Comment Set 31

Re: A.99-09-029 - Pacific Gas and Electric Company Northeast San Jose Transmission Reinforcement Project - Comments on the Draft EIR

EXHIBIT C

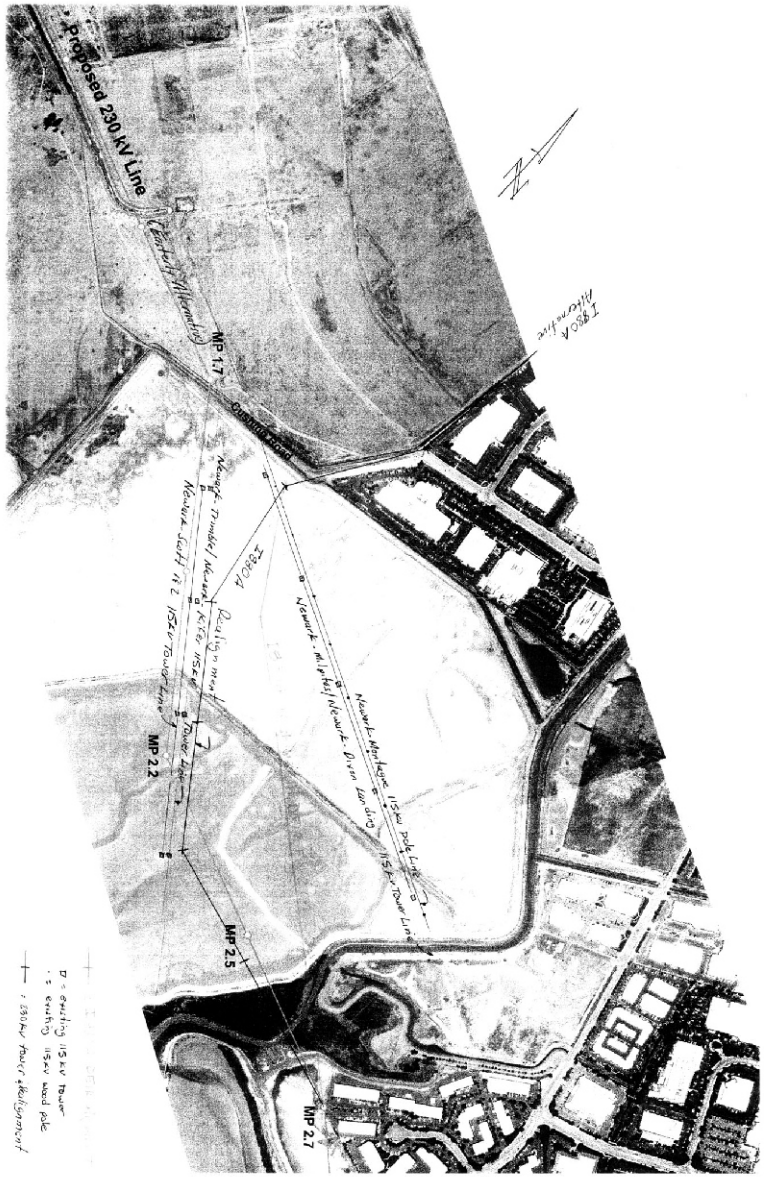
Figure B.6-3 on page B-55 should be revised as shown in Exhibit C to reflect variants proposed in this comment letter in Section C.7 Land Use and Public Recreation.
